# Introduction

## Purpose of this Report

This Response to Submissions Design Report has been prepared by Foster+Partners on behalf of the Pitt Street Developer North Pty Ltd to address the matters raised by government agencies, the public and community organisation groups during public exhibition of the proposed Sydney Metro Pitt Street North Over Station Development (OSD) State Significant Development (**SSD**).

#### Minor updates to the 'Fifth Facade' Design

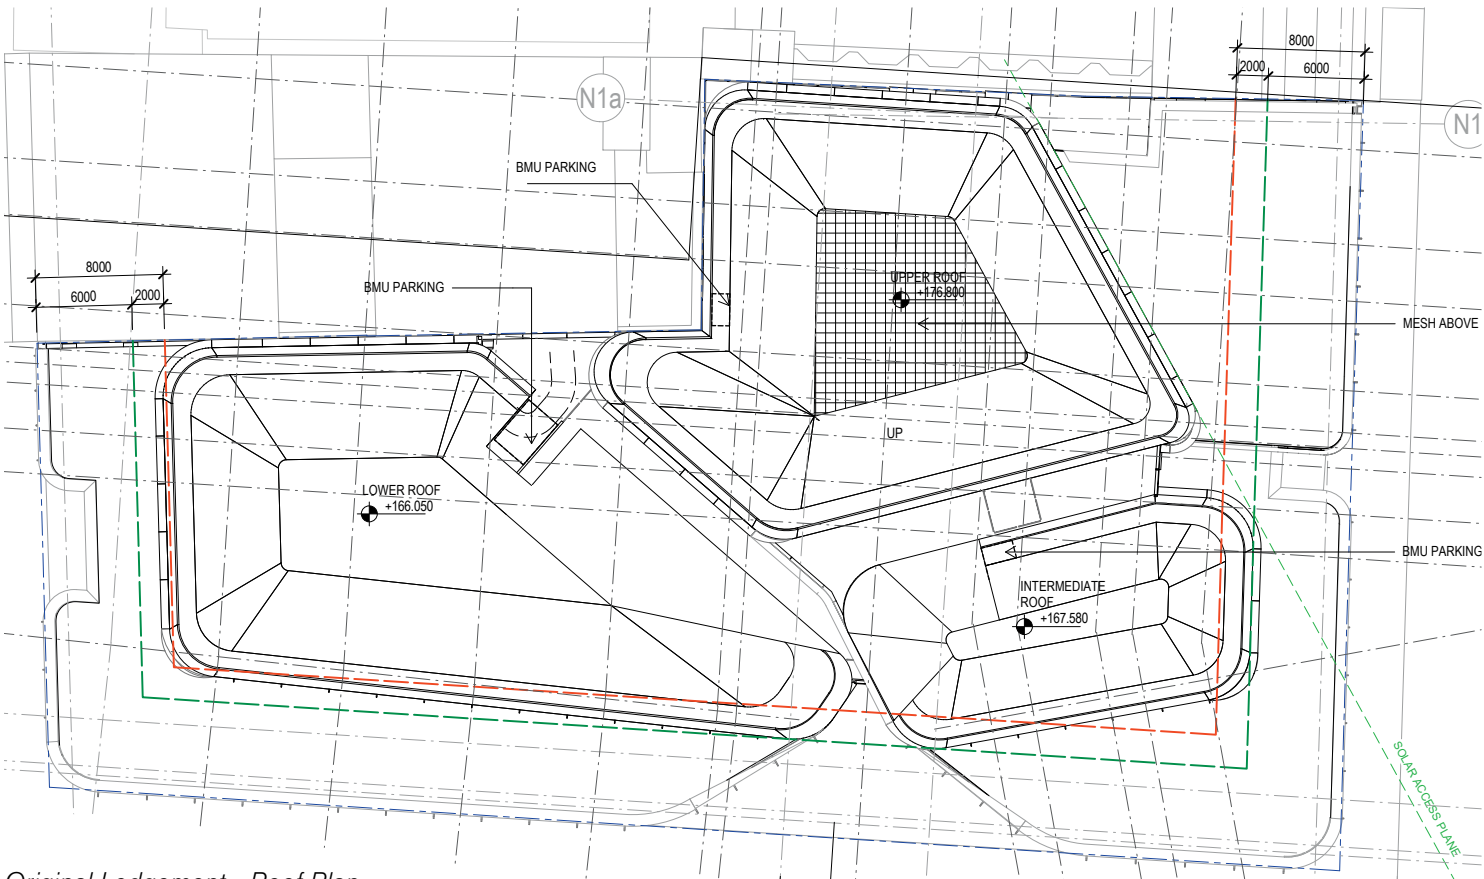
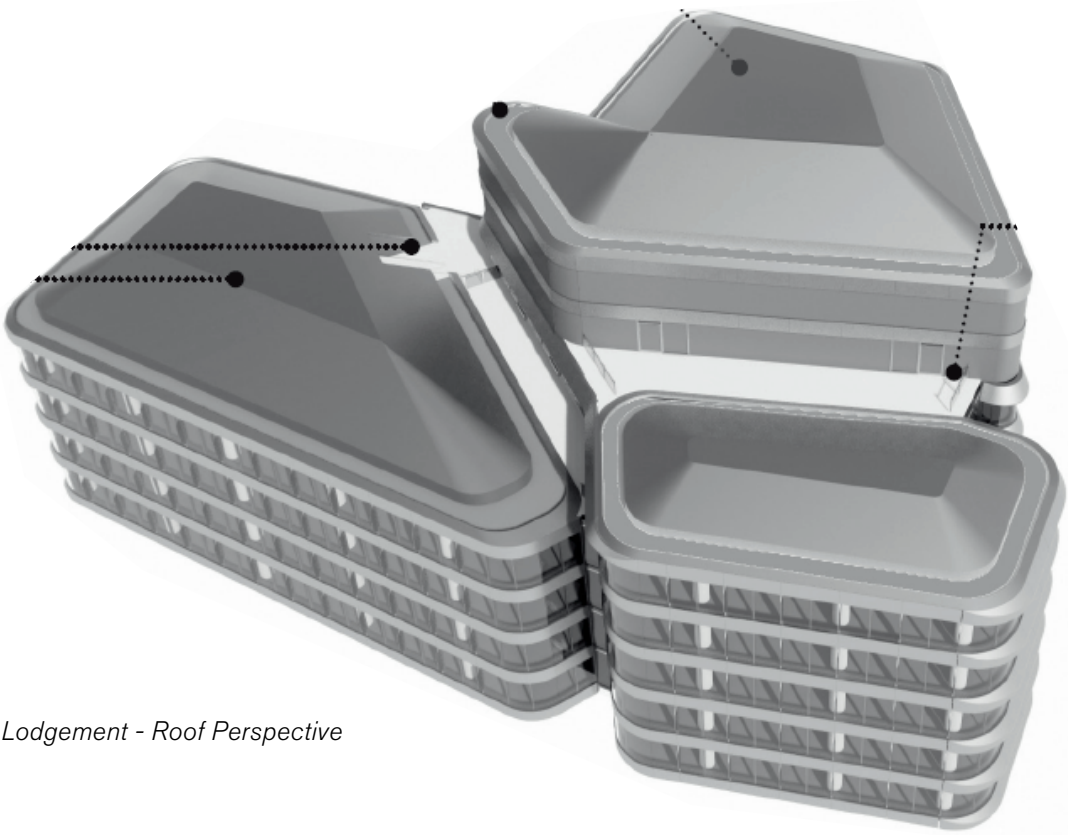
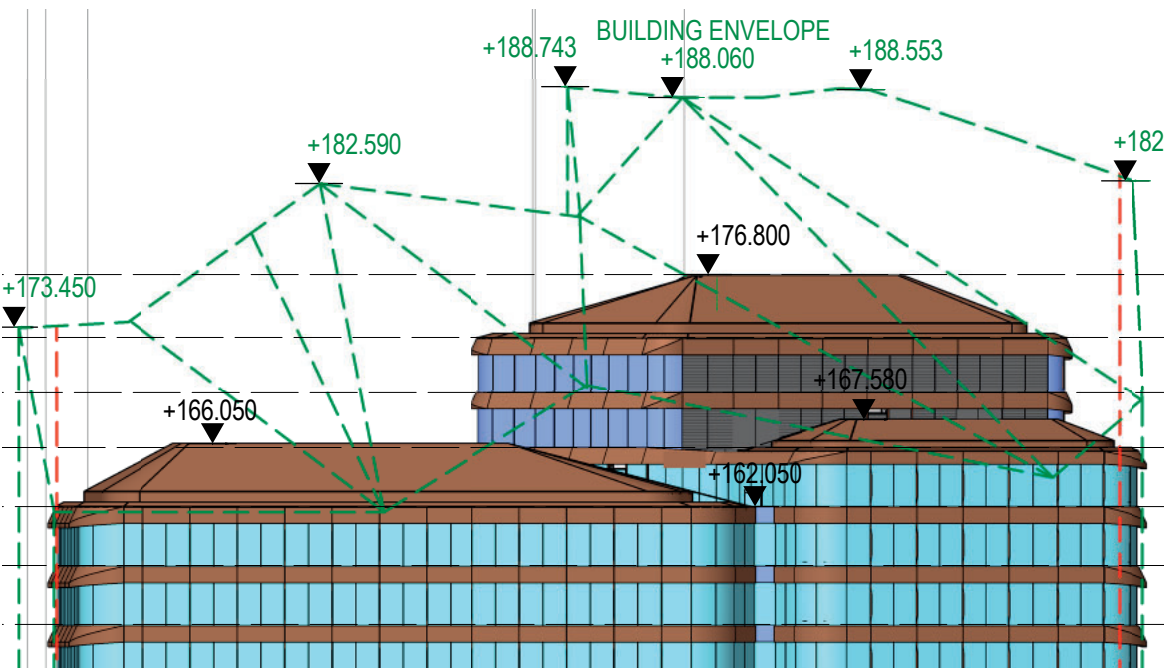
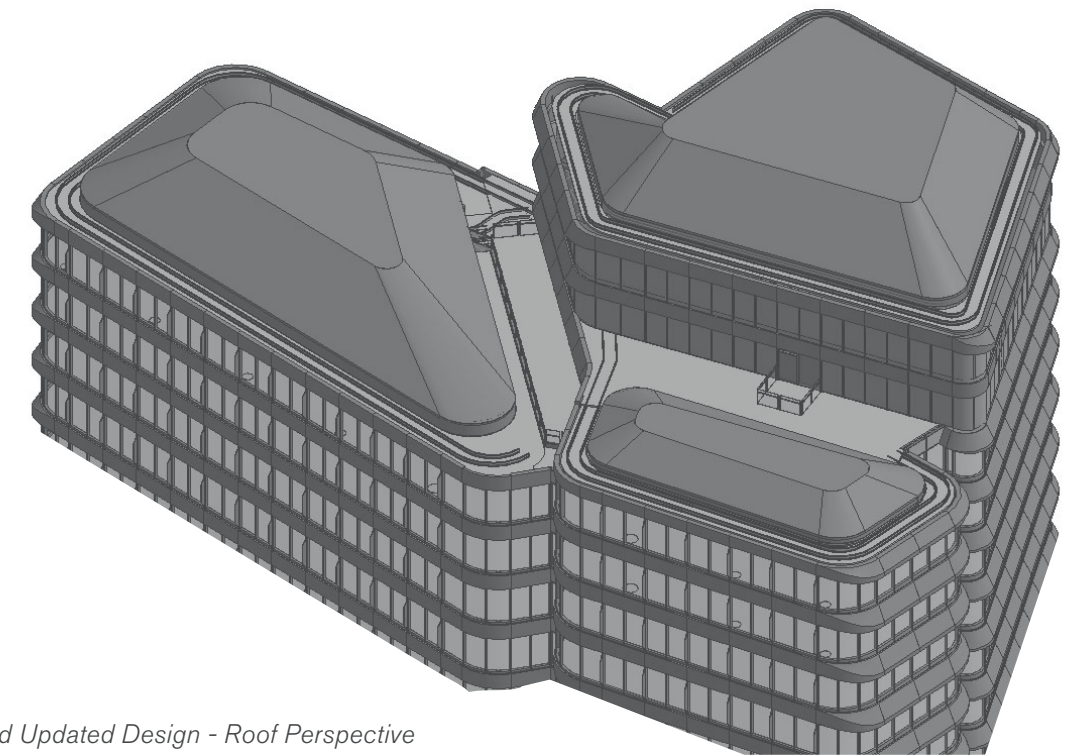
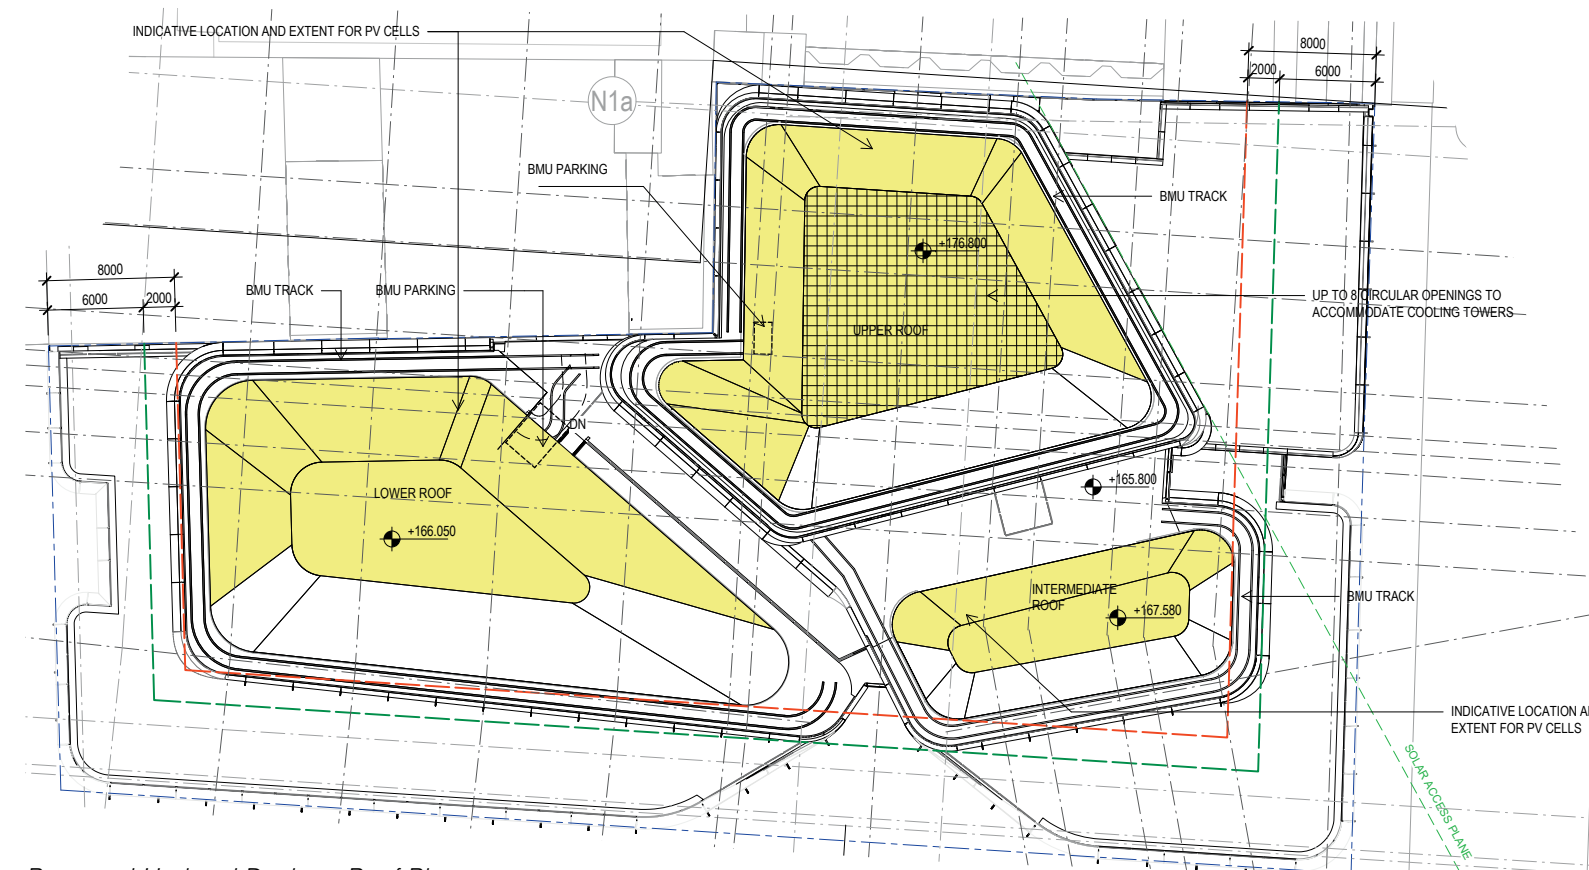
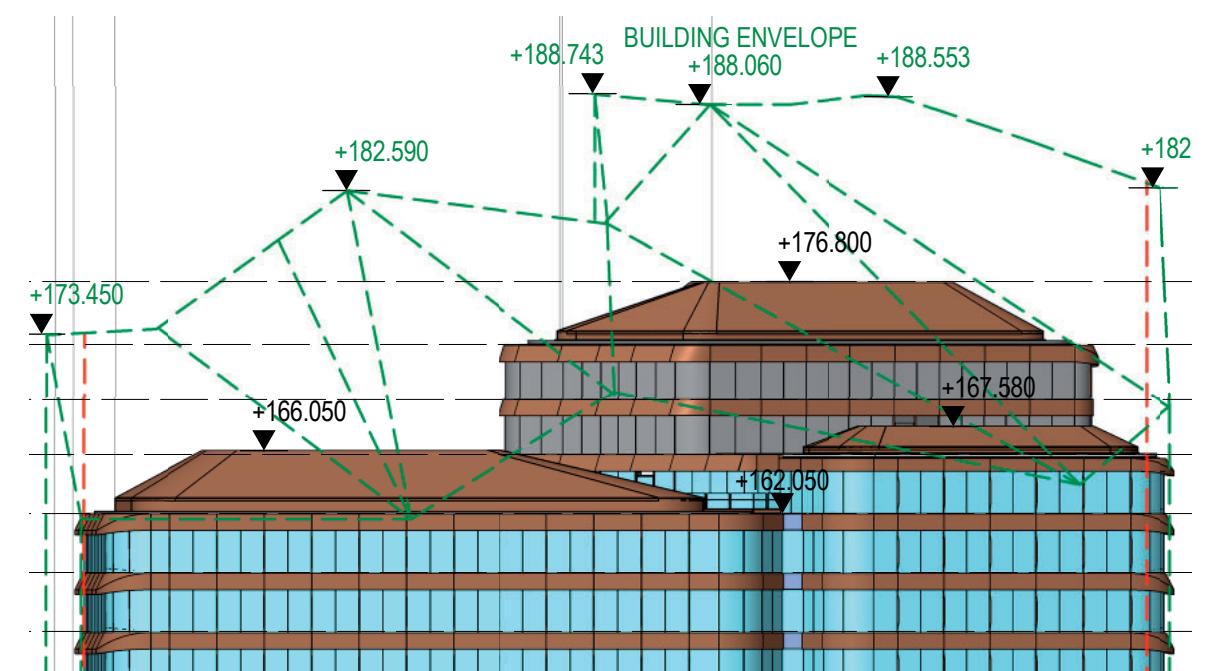
The following pages focusses on the original design of the roof and the external changes proposed to be implemented to the Roof design, providing a plan, elevational and perspective comparisons between the original (~ie SSDA original lodgement) and the proposed updated design:

The revised three stepped roof volumes at the top of the Pitt Street North Development remains wholly contained within the building envelope, with the RLs of the original submission remaining unchanged. However the shape of the flat top surfaces of the roof have been amended to soften their appearance and bring them more in alignment with the design philosophy and organic nature of the rest of the building as can be seen on the plan and 3D perspective on this page.

Additional detail has been added in the form of the BMU tracks which sit within the recessed slot at the perimeter of each roof volume. As a result of detailed coordination with specialist access and maintenance consultants, we have been able to ensure that the BMUs can be hidden entirely within the massing of the building (Intermediate and highest roof volume) or hidden below the slope of the roof (lowest roof volume) when not in operation.

The above mentioned changes have no further impact on the overall building GFA, the overshadowing of the building to Hyde Park nor on the Park Regis Tower solar access as established in Chapter 1 of this report.

Proposed Updated Design

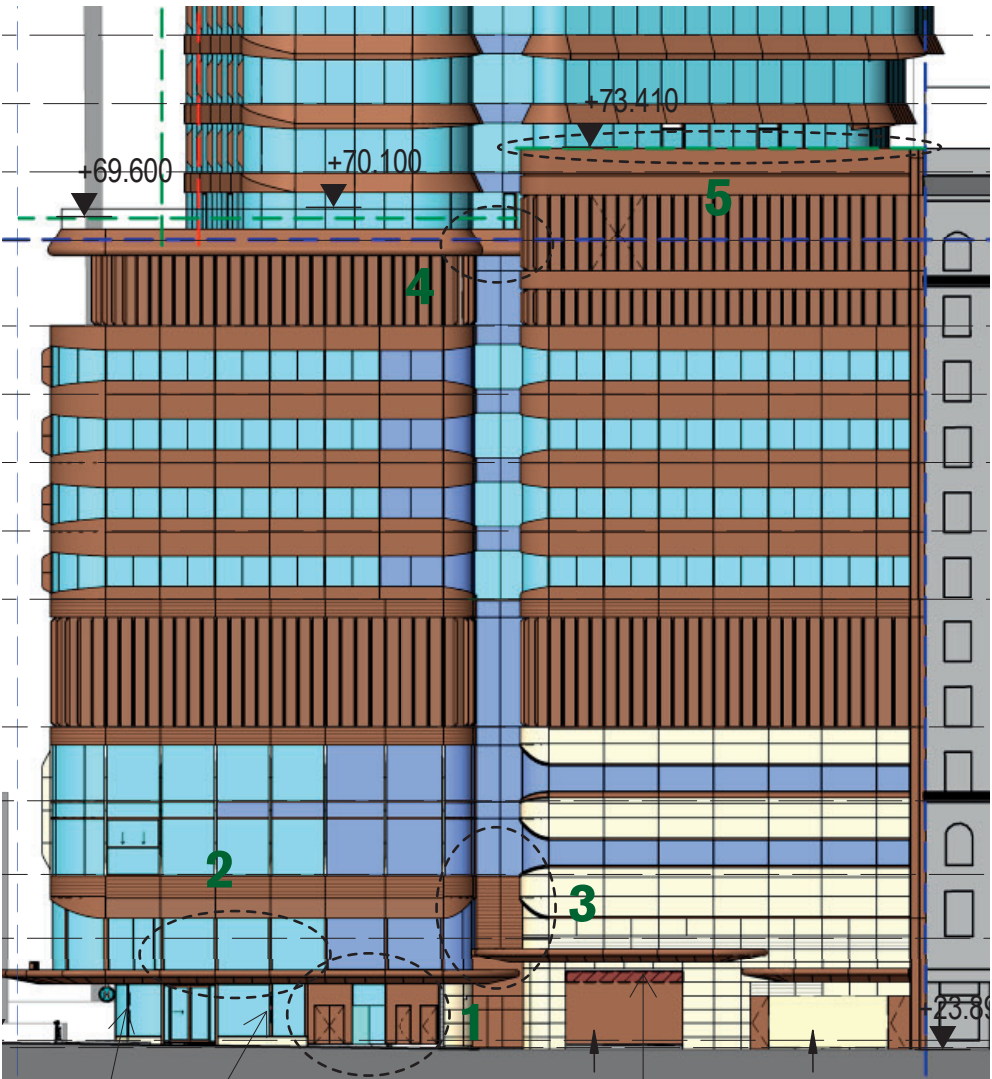
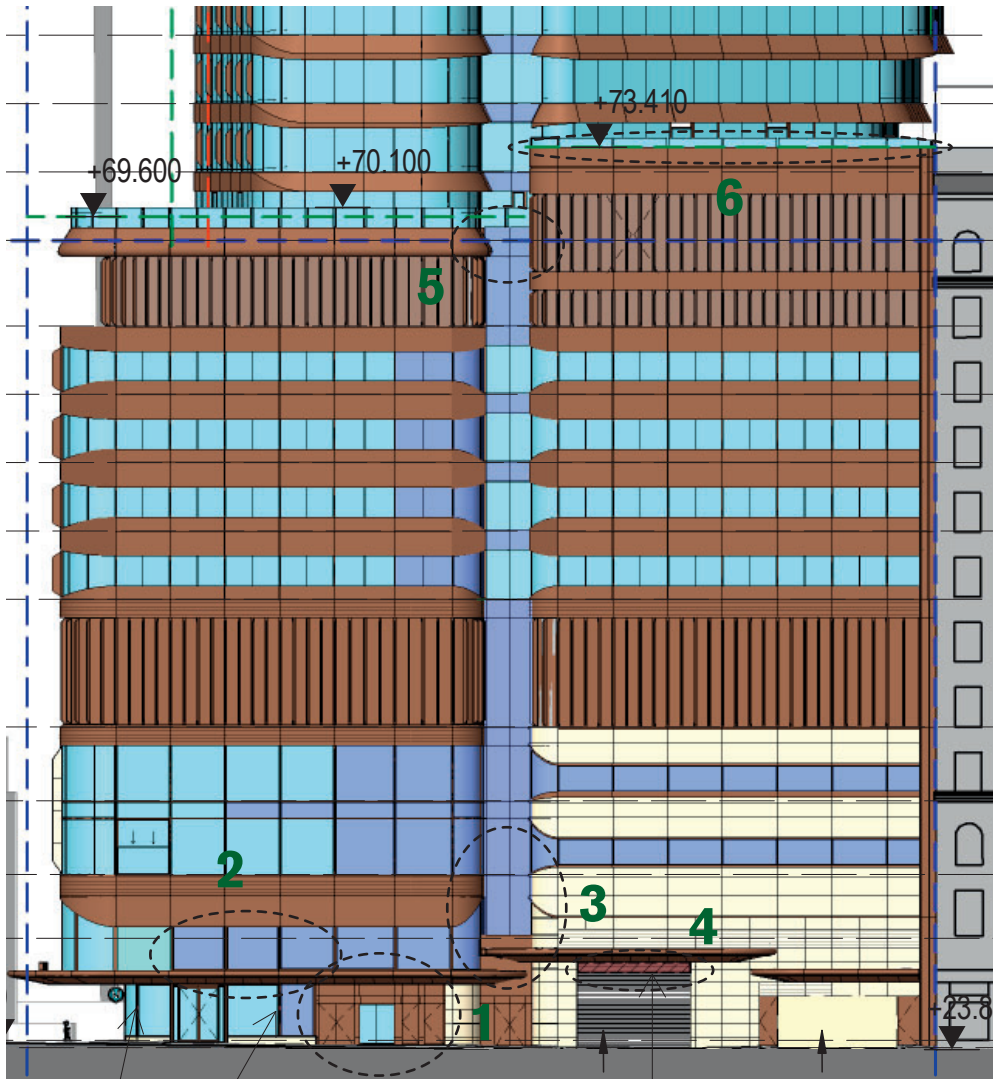
1. End of trip glass entrance door has been set into a bronze clad portal to better integrate it into the overall facade
2. Station plantroom facade on level 1 has been updated to a back-painted glass facade. This was an error in the original lodgement

5. The top of the slot has been revised to be a glass spandrel panel to better accentuate the two podium volumes either side of the podium slot.
6. A glazed upstand / balustrade has been added to the top of the solid upstand on the NE corner of the development on level 11. This was an error in the original lodgement drawings, although it was noted in the Architectural Design report.

### Minor updates to Building Facades

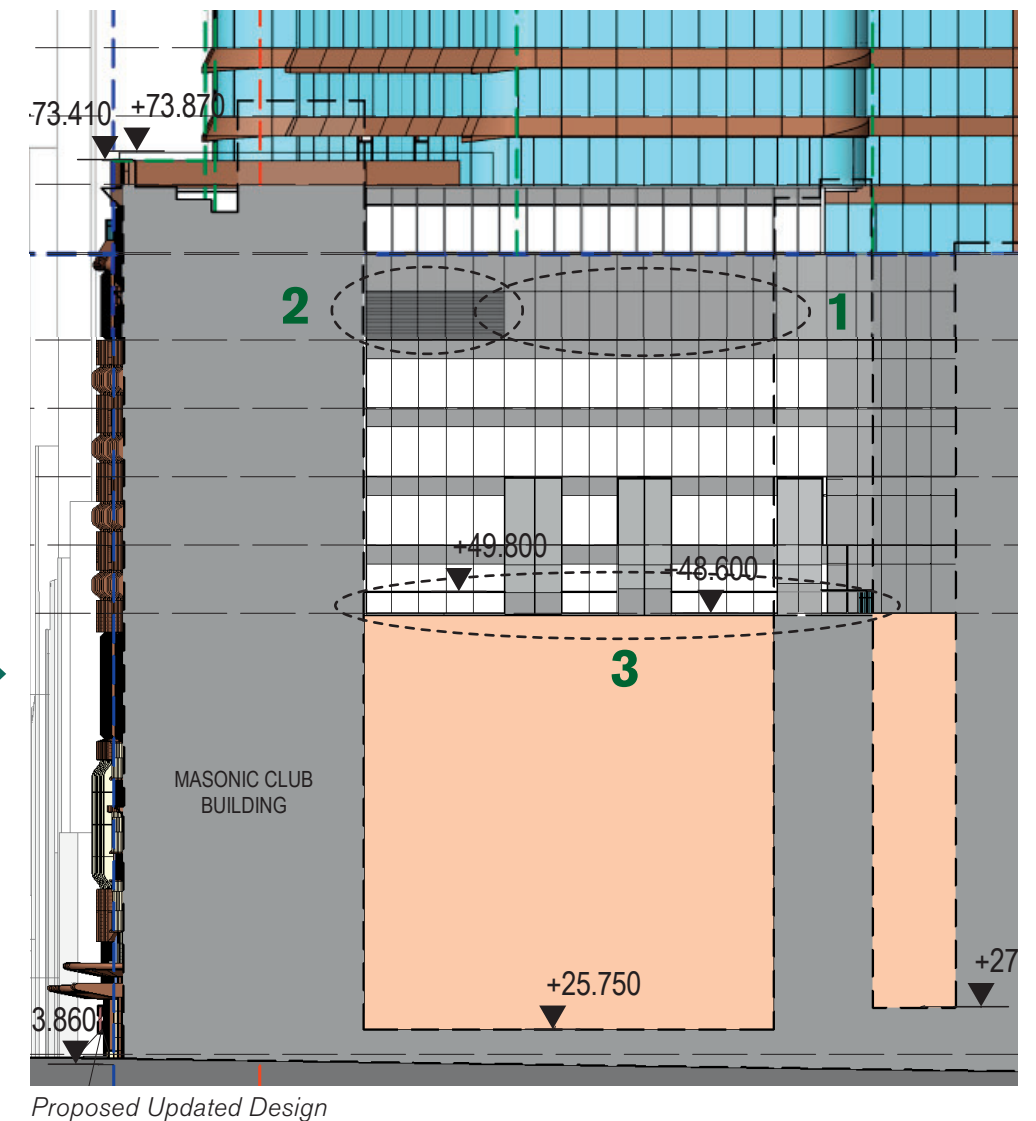
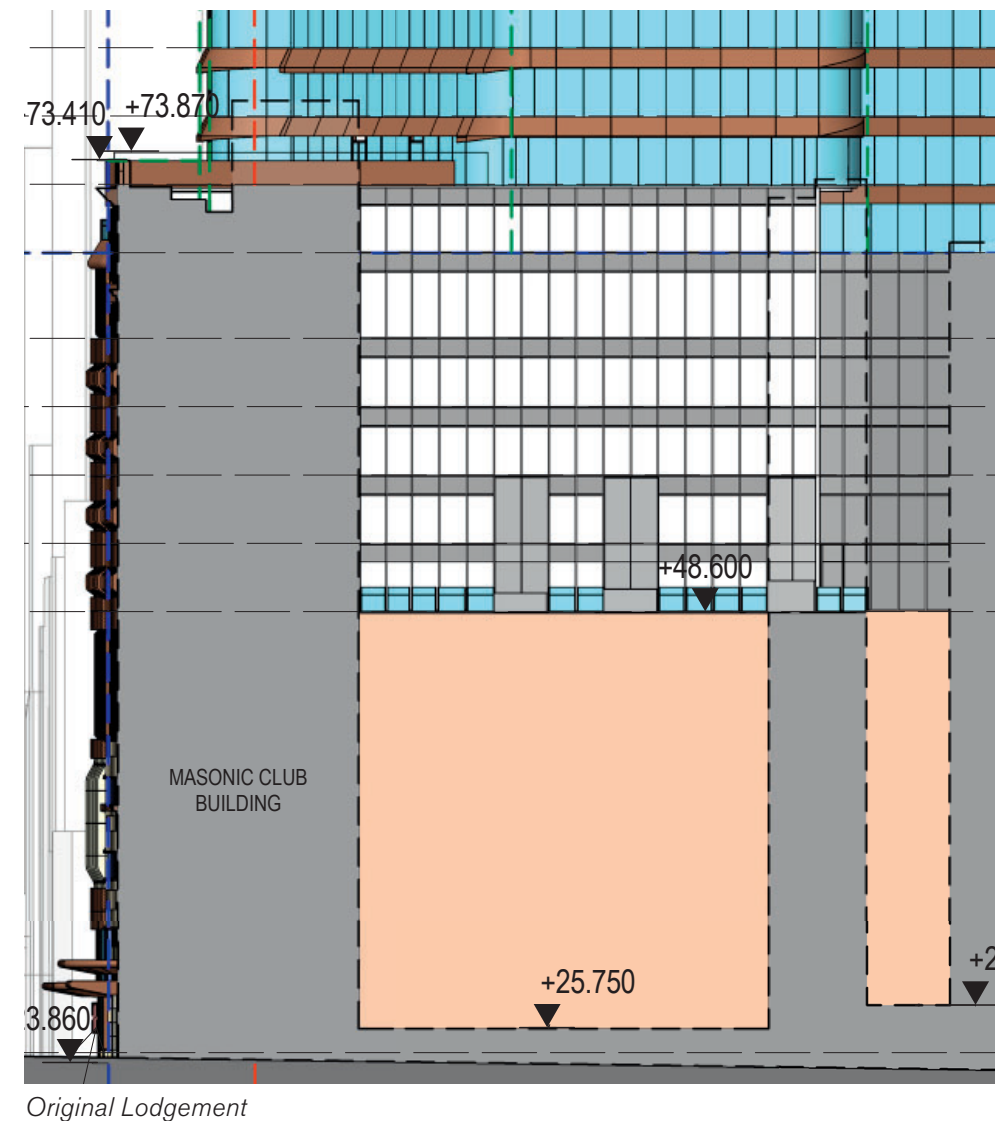
1. The north-facing Level 9 plantroom facade has been revised to have reflective white back-painted glazing to match the spandrel panel above and below the plantroom. This change was introduced to ensure there are no obscured views into the plantroom, nor any difference in light temperature between commercial levels above and below and plantroom level that can be noticed from the NSW Masonic Club.
2. White aluminium intake louvers have been introduced to the level 9 plantroom facade, thus ensuring that they are carefully integrated with and match the white back-painted glazing adjacent to it.
3. The balustrade to the maintenance area to the North of Level 5 has been revised to be a minimal metal framing, thus ensuring minimal obstruction of the reflected daylight into the NSW Masonic lightwell below.
